Bulletin #4

Project: Niles-Barnard House Renovation

Project No: 0128-18-0020

Date: July 8, 2020

FIRST FLOOR PLAN

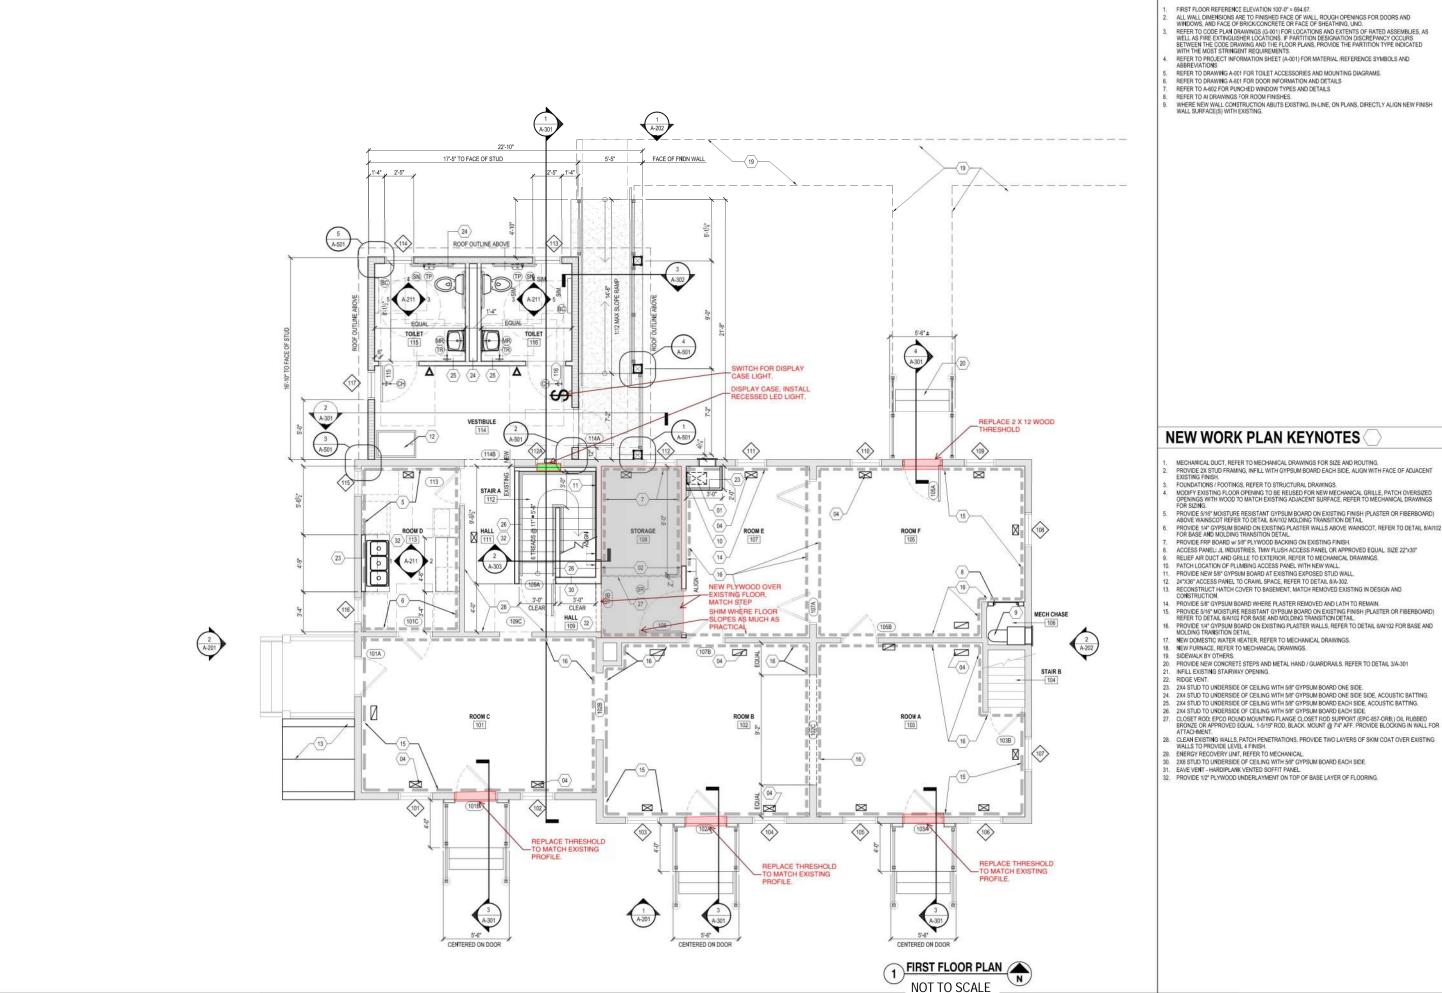
Replace 4 door thresholds at existing exterior doors as indicated on attached sketch. Profile to match existing.

Add recessed puck lighting at display window and switch at entry door. Provide cut sheet of recommended lighting product w/ pricing.

Add plywood at storage in area indicated to provide flush finish subfloor for LVT flooring install.
